Certificate of Appropriateness for  
1314 Jenifer St

July 29, 2019

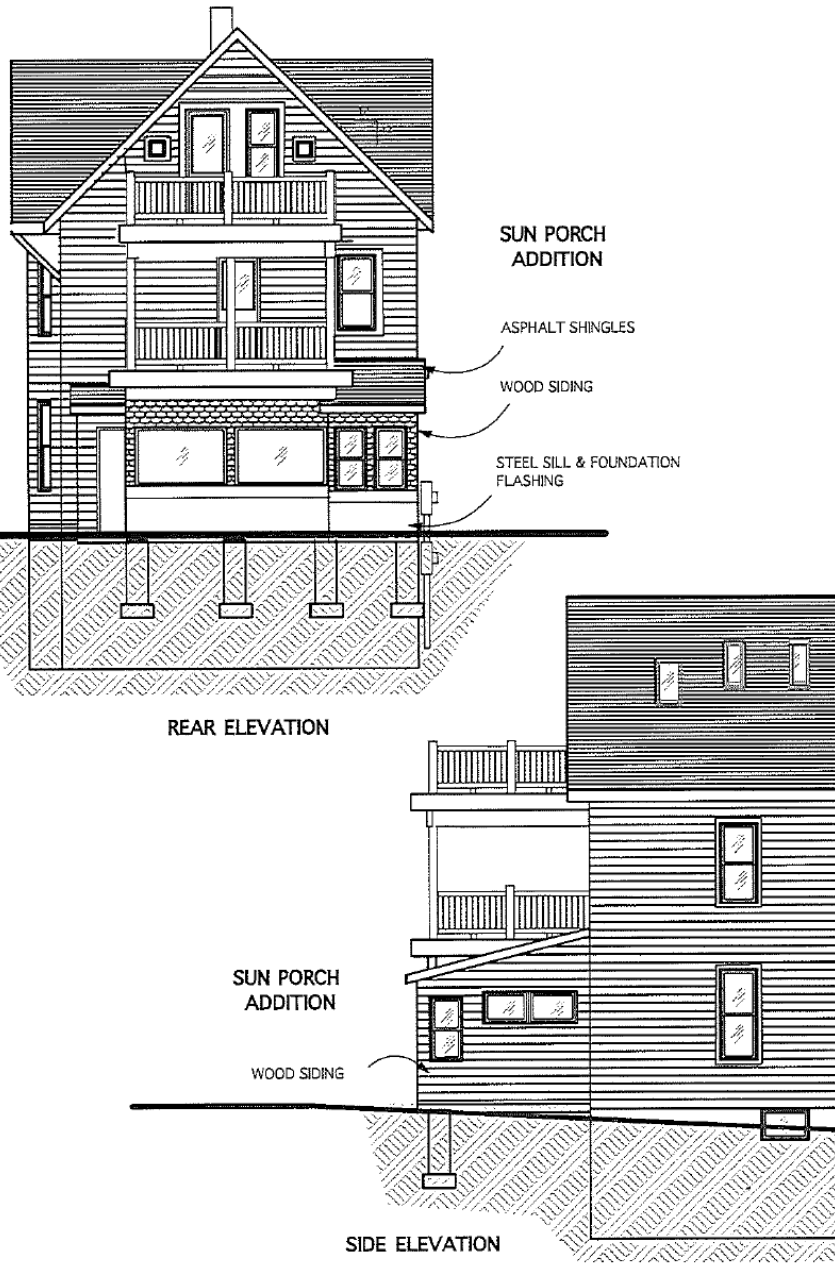
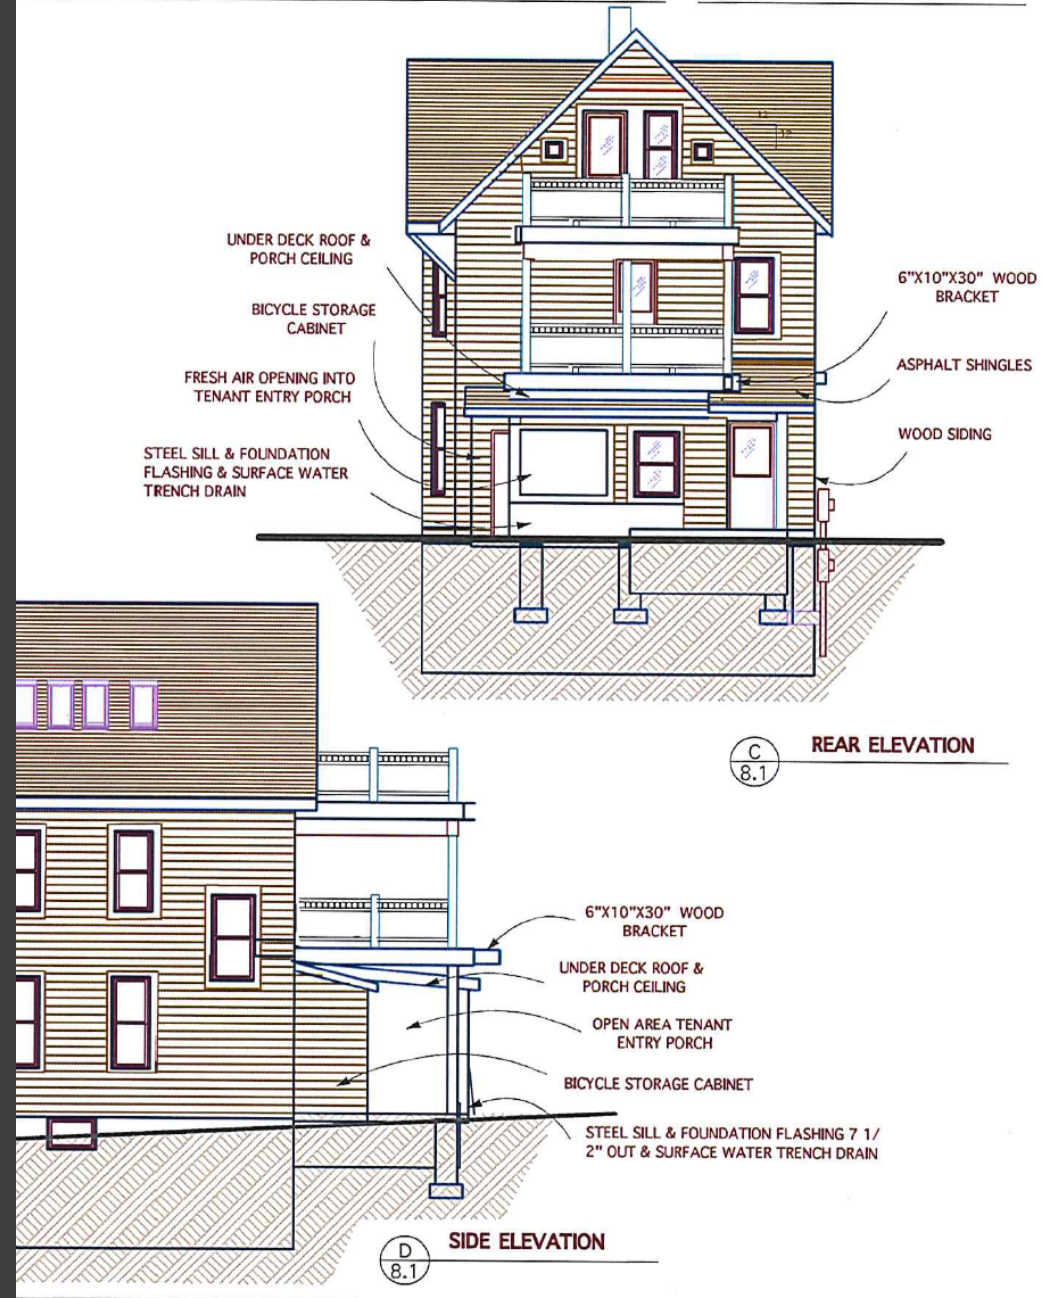
2018 proposal

Current proposal

1. Deny installation of the solar lights on the third floor deck
2. Siding for any enclosed sections of the porch should be lap siding that terminates at an apron board to transition to the foundation material
3. Apron board must be flush with the wall plane and may be wrapped with aluminum
4. Eastern picture window on rear porch should be removed or centered on bay for the enclosed porch entry with siding or trim details to be approved by staff.
